# 400 Gb/s 100-m 8-pair MMF objective baseline proposal

IEEE P802.3cm, Pittsburgh, May 2018

**Table 138-3—Physical Layer clauses associated with the 200GBASE-SR4 PMD**

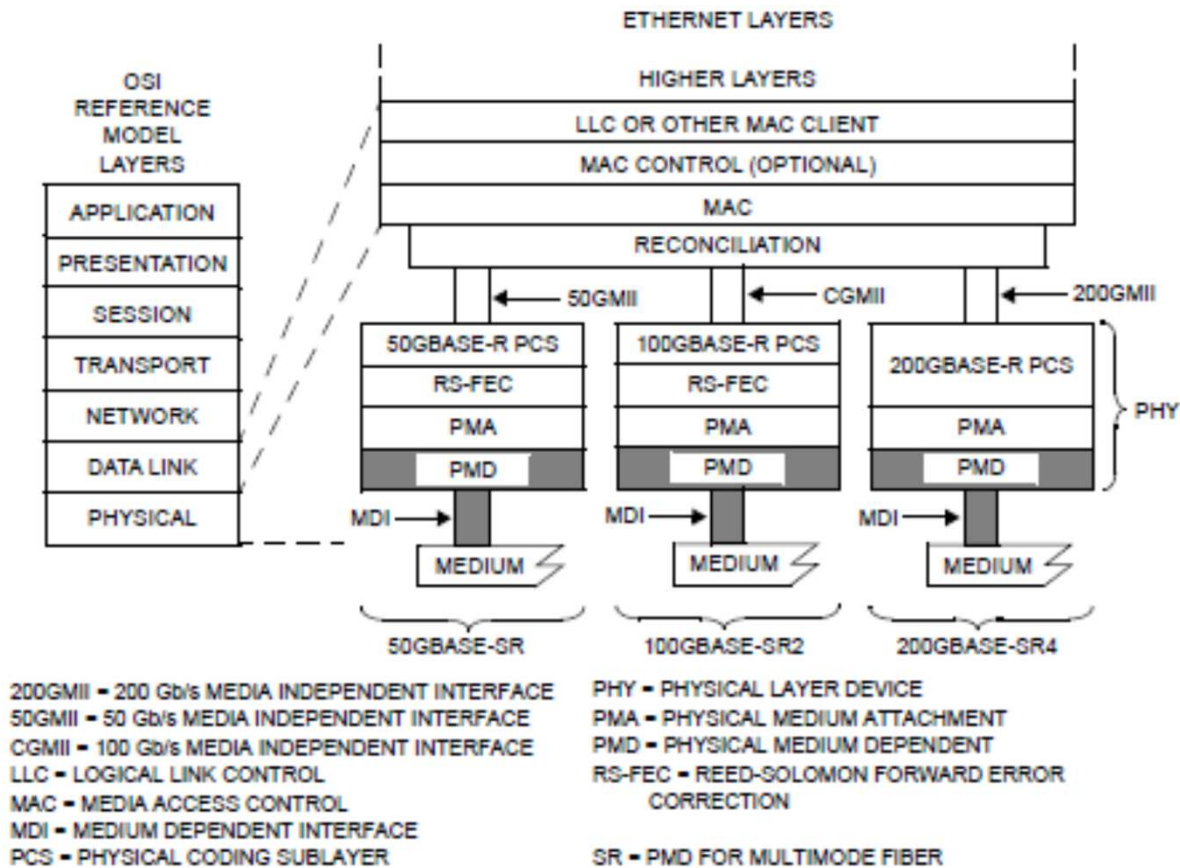
Add new table for 400GBASE-SR8 after Table 138-3 with content the same as Table 138-3 except as noted. Change each instance.

- Change 200G to 400G
- Change SR4 to SR8
- Change 120B to 120C for C2M
- Change AUI-8 to AUI-16
- Change 120D to 120E for C2M
- Change AUI-4 to AUI-8

Increment trailing table numbers.

# Block diagram for 400GBASE-SR8 transmit/receive paths

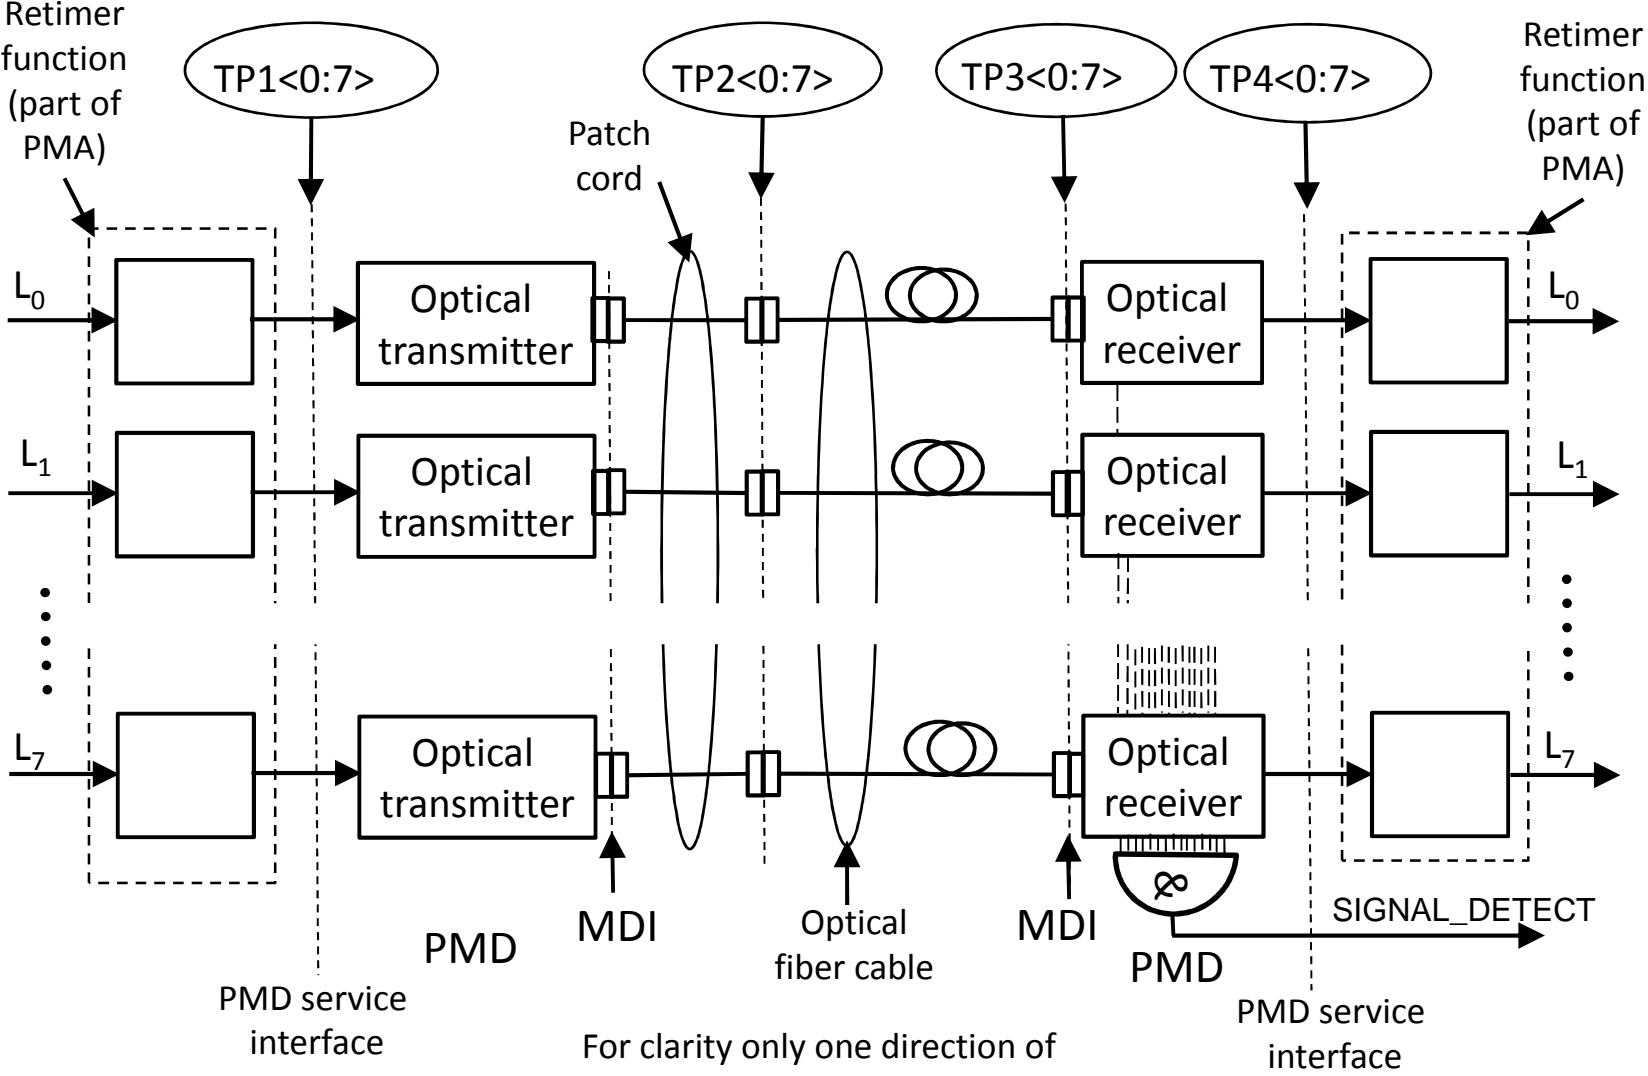
For 138.5.1 replace paragraph 1 with:

The PMD block diagram for 400GBASE-SR8 is shown in Figure 138–2. The block diagrams for 200GBASE-SR4, 100GBASE-SR2 and 50GBASE-SR are equivalent to Figure 138–2, but for four lanes, two lanes and one lane per direction, respectively.

Replace Figure 138-2 with the diagram on the next slide.
